FACILITY: SAN ONOFRE NUCLEAR GENERATING STATION, UNITS 2 AND 3

SUBJECT: SUMMARY OF SAN ONOFRE MEETING ON CONFIRMATORY ANALYSIS
OF PIPING SYSTEM DESIGN

CONFIRMATORY ANALYSIS
OF PIPING SYSTEM DESIGN
FOR SAN ONOFRE UNITS 2 & 3

FIG 9
FREQUENCY COMPARISON

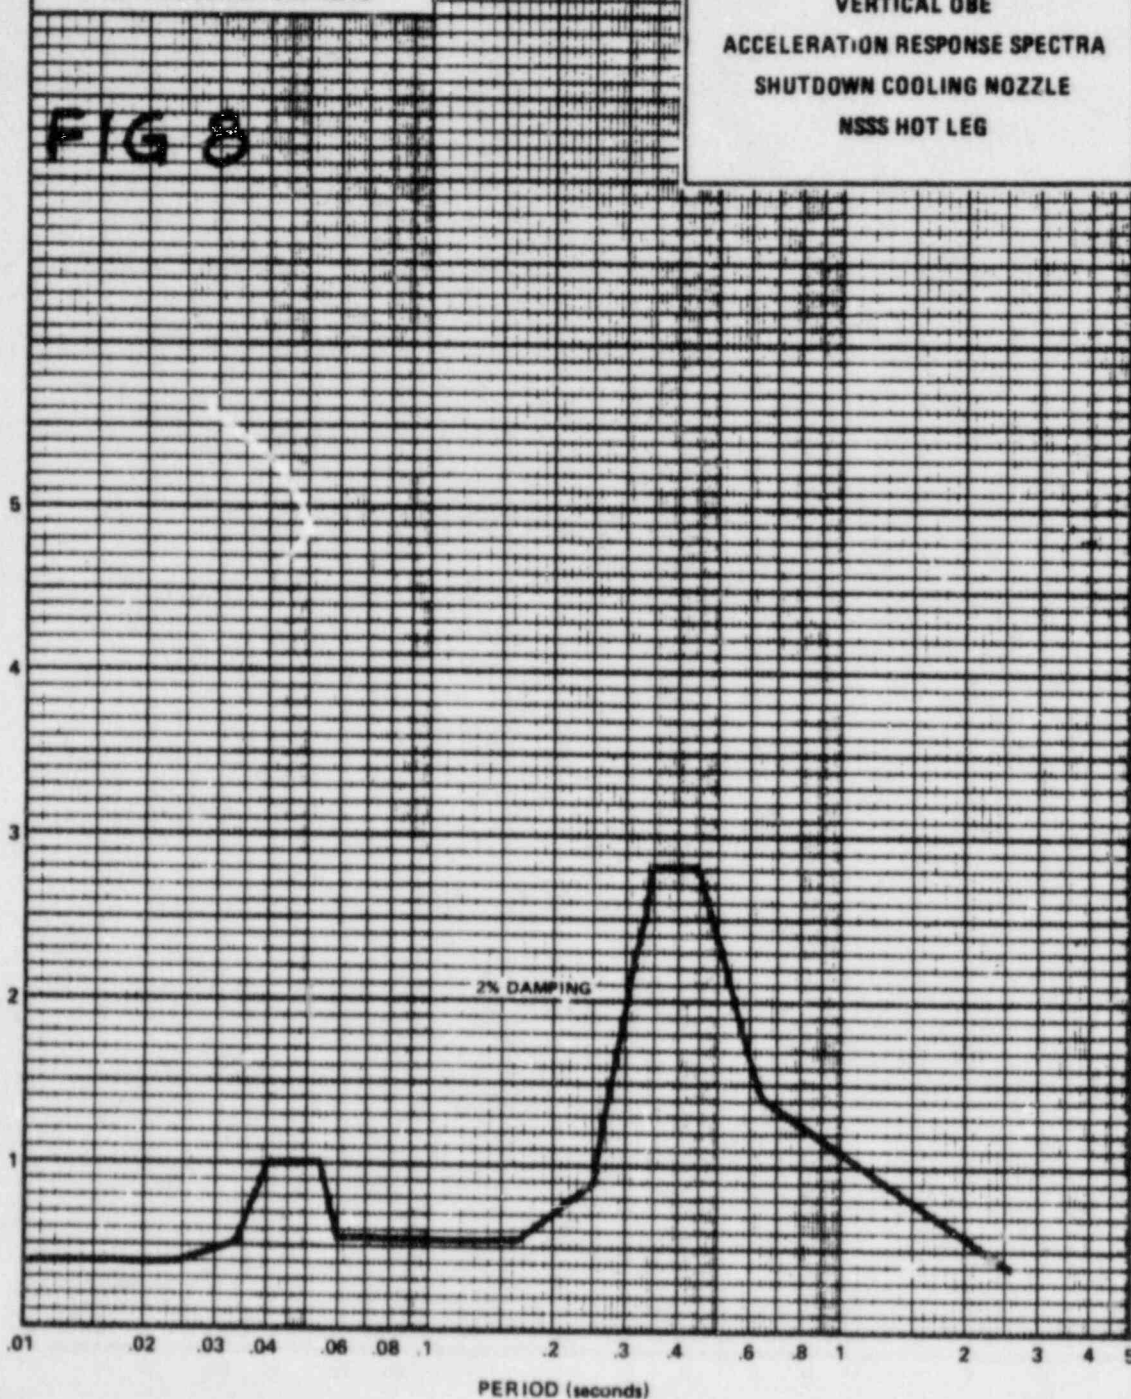
The incorporation of only the snubber flexibilities into the analysis for this system is inappropriate since the stiffness characteristics of the remaining system supports are of the same order of magnitude as the snubber stiffnesses. Therefore if snubber flexibilities are to be included in analysis, all support flexibilities should be included for consistent methodology. The significance of this fact can be seen in Figure (9).

FIG 15

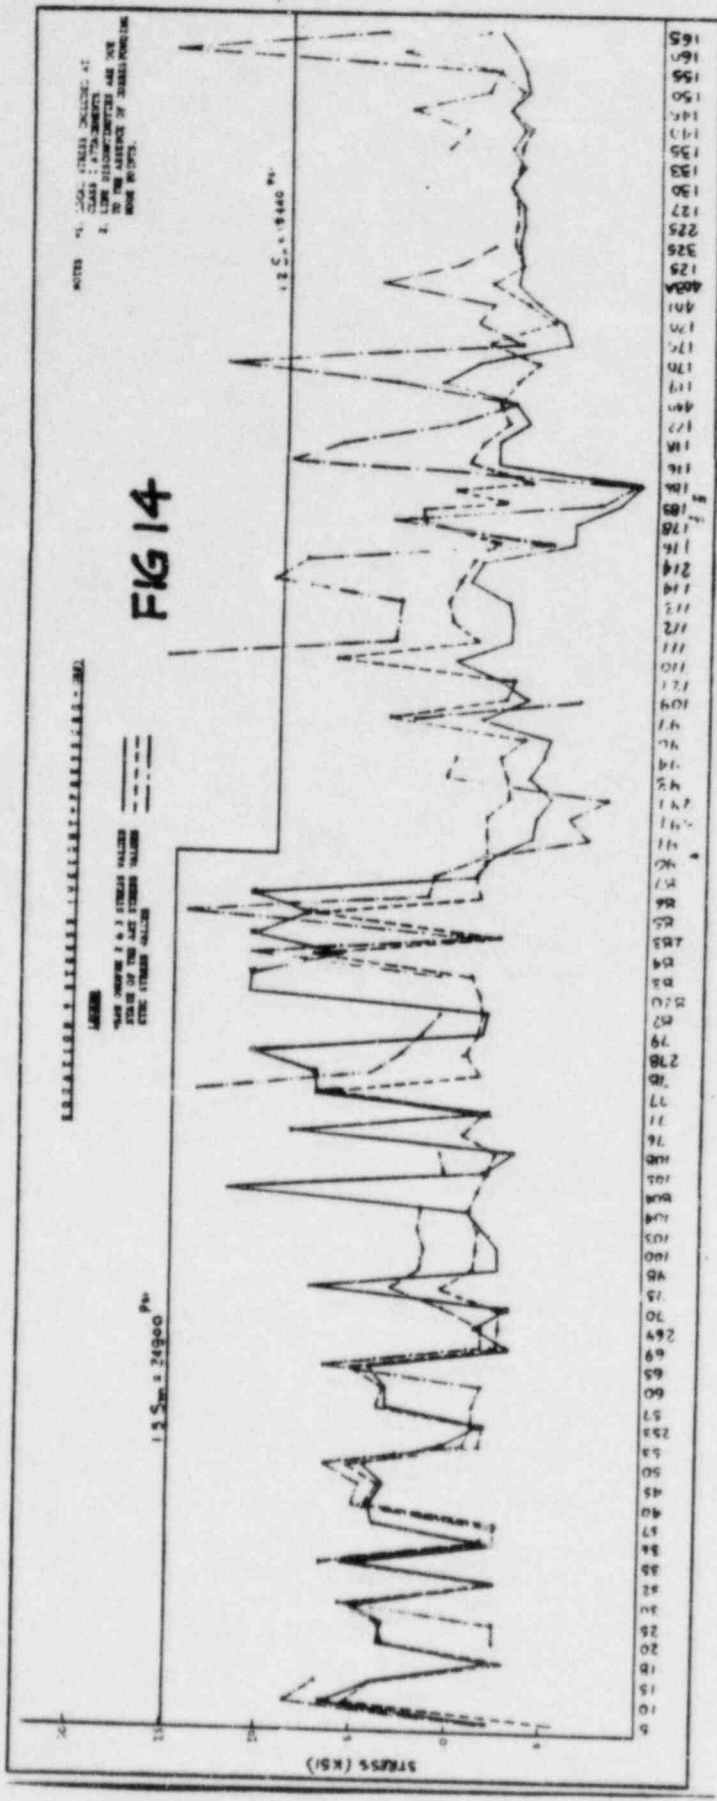
As is clearly shown by Figures 14, 15, and 17, the stresses and loads developed by a recent state of the art analysis using consistent methodology differ but little from the loads and stresses calculated in the original design analysis.

FIG 17

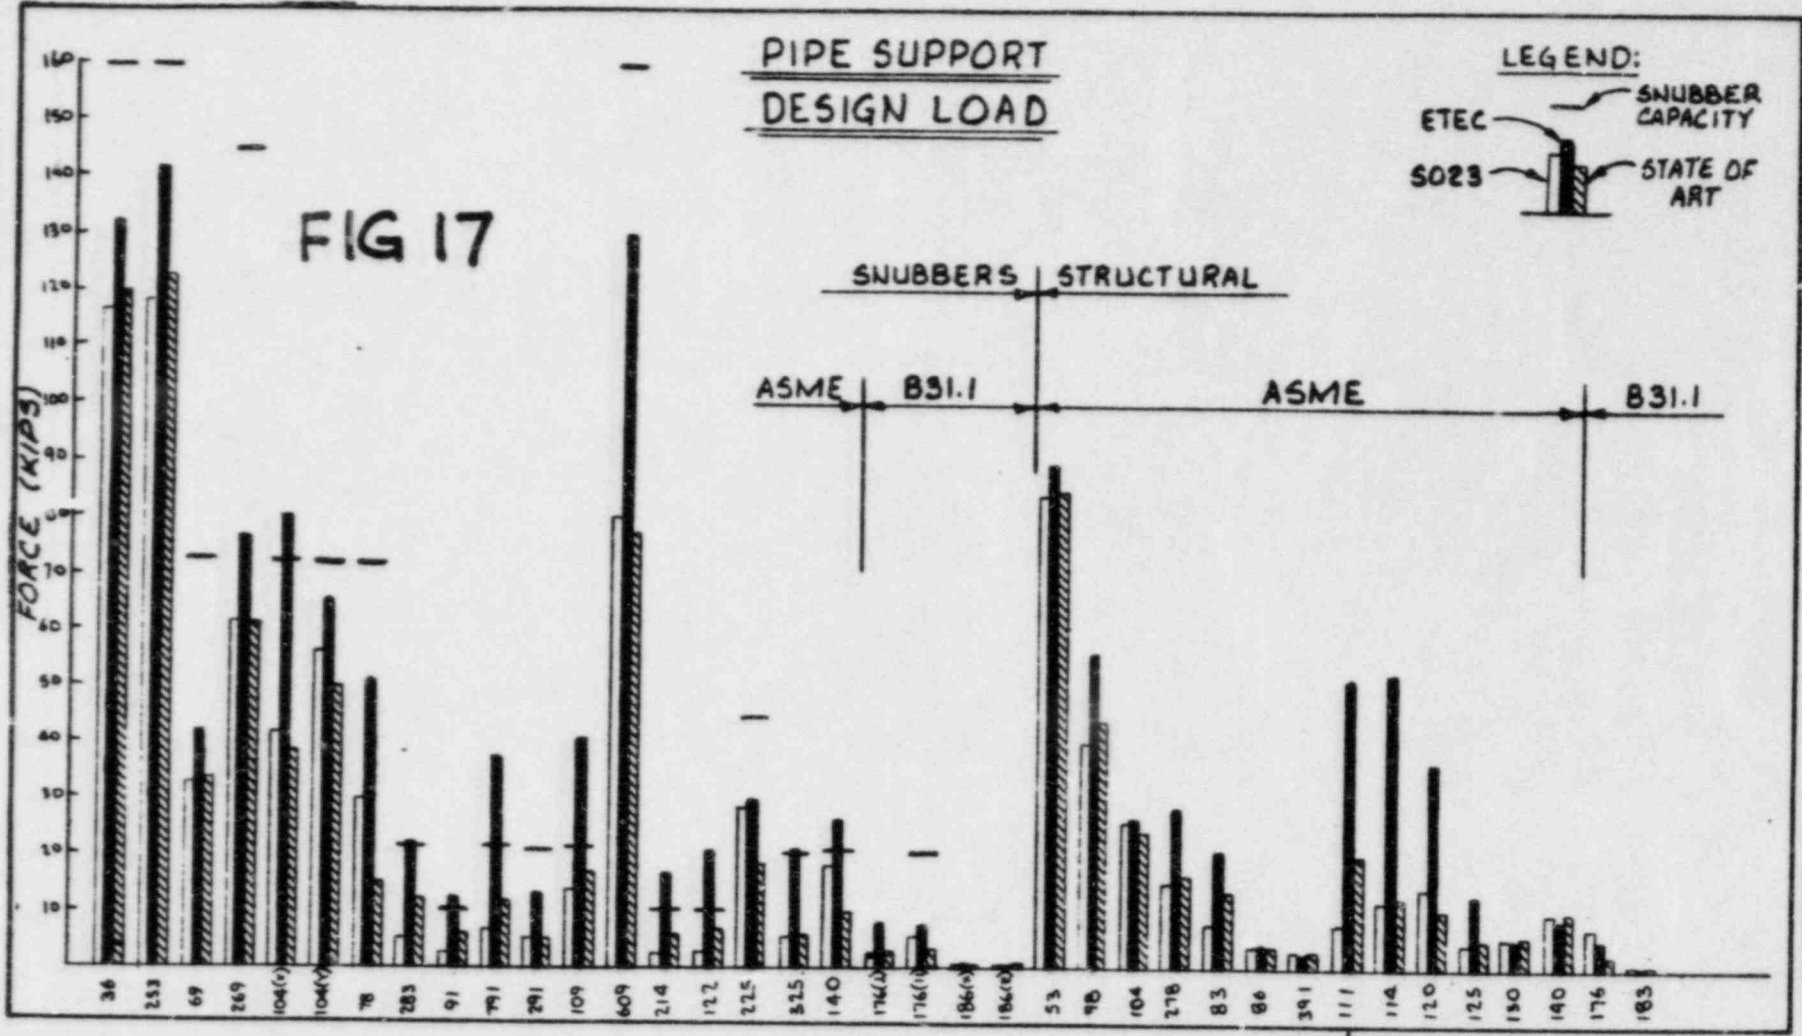
5. As shown in Figure 17, the imposed loads on the large highly loaded snubbers changed very little between the original analysis and the state of the art analysis. Further, the large snubbers all have significant margins to rated capacity.
